Planning Commission

Regular Meeting Agenda
March 25, 2024 | 6:30 PM
Peachtree City City Hall

SUBJECT: Conceptual Plat, Peachtree Court Townhomes, 135 Peachtree Court

SUBJECT: Conceptual Site Plan, Primrose School, 110 Wilshire Village Drive

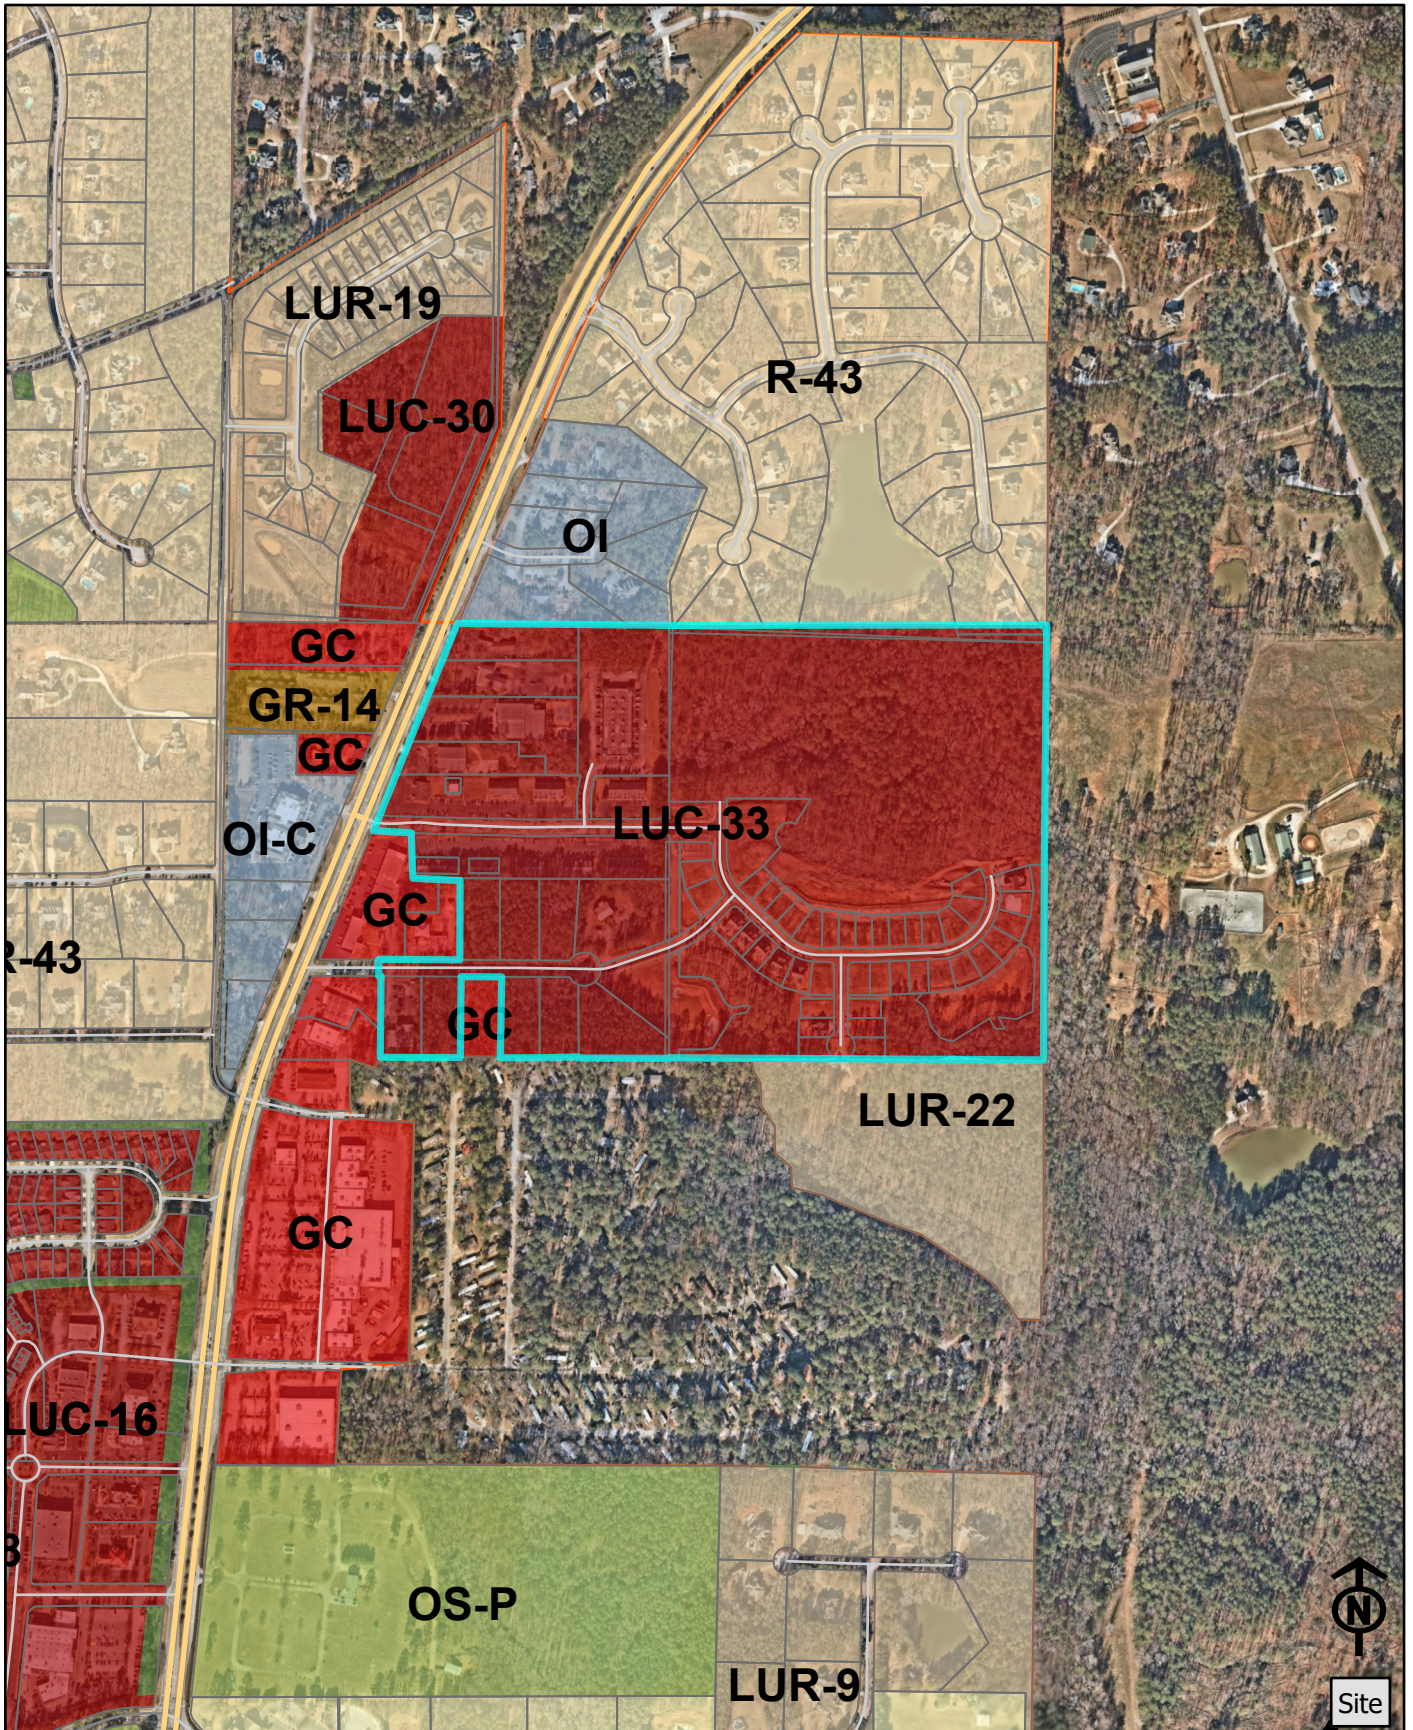
- o Staff Comment: Combined with the Towson Place single-family residential neighborhood, the Peachtree Court townhomes will result in a total of 55.5 acres of the 75-acre development used for residential-only. This equates to 73% of the total land being used for residential-only uses.

- Maximum 12 dwelling units per acre for attached residential.
 - o Staff Comment: The proposed density is 6.7 du/acre, thereby meeting this requirement.

- o Staff Comment: The conceptual plat shows a street-stub to the southern property line, thereby satisfying this zoning requirement.
- Sidewalks shall be provided on Peachtree Court.

- o Staff Comment: sidewalks are shown on the development's side of Peachtree

- Parking ratios shall be a minimum of one per attached dwelling unit.
 - Staff Comments: 2 garage parking spaces are shown per unit. In addition, 39 off-street parking spaces are evenly distributed throughout, allowing for visitor parking. This exceeds the zoning requirements.

- Staff Comment: the concept plat shows the street trees as required.
- Maximum building setback from Peachtree Court shall be 12 feet.
 - Staff Comment: the concept plat satisfies this requirement.

- Side setbacks are zero, provided the fire codes are satisfied and that there is at least 10 feet between detached buildings.
 - Staff Comment: the plat meets this requirement.

Section 706 of the Land Development Ordinance (LDO) states that, "the planning commission shall require multi-use paths ... from residential and commercial developments." The master plan approved as part of the LUC-33 zoning required a path between the single-family residential portion and the mixed-use portion on the northern side of the development, near Longboat subdivision. No other path connections were required per the zoning.

Should the planning commission find it appropriate, they can require that the sidewalk along Peachtree Court be widened from 5 feet to 10 feet to serve as a multi-use path. The City has allowed a portion of a path to be located within the street right-of-way in other parts of the City, so long as the maintenance responsibility of the path remains with the developer and/or HOA.

The LDO requires at least three (3) acres of open space per 100 dwelling units. With 37 units, this equates to 1.1 acre of open space. The concept plat shows 1.5 acres, not including the stormwater maintenance facility, as open space, thereby meeting this

Staff is of the opinion that the conceptual plat meets the zoning conditions and the LDO standards. Staff recommends that the Planning Commission consider approving the plat with the following condition:

1. The sidewalk along Peachtree Court shall be constructed as a multi-use path.

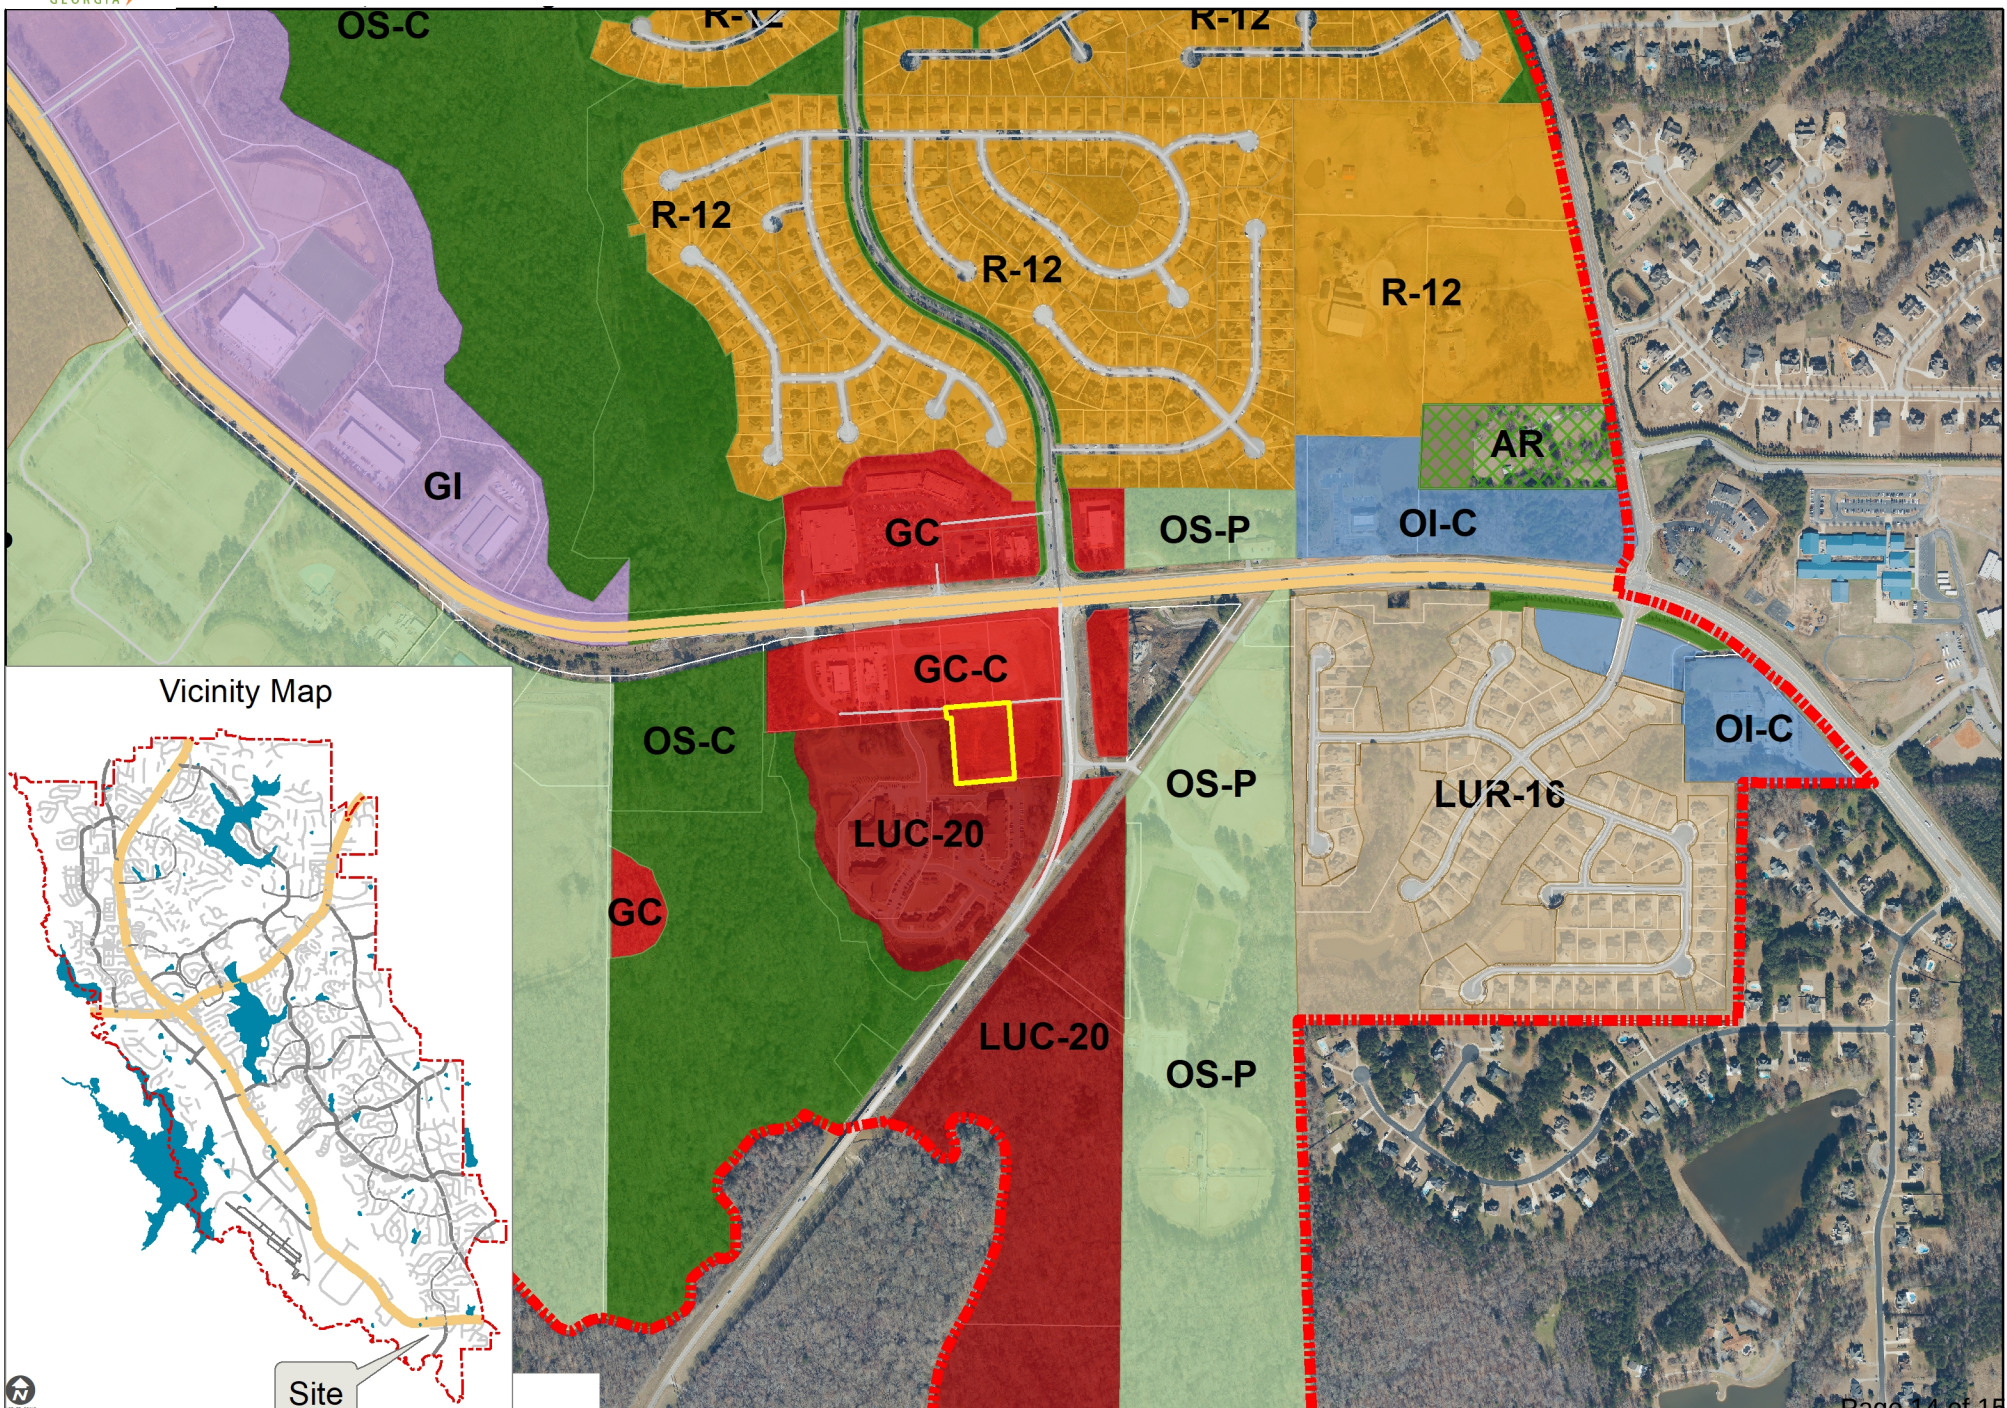
The property is larger than 40,000 square feet and inter-parcel access is provided. Chapter 290-2(aa) of the Georgia Family and Children Services Rules and Regulations pertain to the physical space requirements of daycare facilities. Staff confirmed that the conceptual site plan meets the minimum outdoor play area size of at least 100 square feet per one-third of the center's capacity for children. The applicant states that the facility is designed for 214 children, equating to a requirement of 6,420 square feet of outdoor play area. The site plan design includes 13,375 square feet of outdoor play space, thereby exceeding this standard.

The site design includes vehicular access to Wilshire Village Drive and a shared drive with the adjacent lot. This inter-parcel connectivity satisfies the zoning conditions.

The parking lot consists of two (2) drive isles lined with 50 parking spaces. This exceeds the minimum parking required of 46 spaces. No golf-cart spaces are provided.

Per the zoning conditions, a 25-foot landscape buffer is required along the property lines adjacent to Somerby. This buffer is shown on the concept plan, but incorrectly labeled as "Undisturbed." There is no zoning condition or development code that requires this buffer to be undisturbed. In fact, the zoning condition states that, "within the buffer, a combination of berms and landscaping is required to provide a permanent vegetative buffer." The applicant will return to the Planning Commission at a later date for their landscape plan review.

Staff is of the opinion that the proposed site plan meets the City's ordinances and standards and recommends approval of the Primrose daycare facility conceptual site plan.
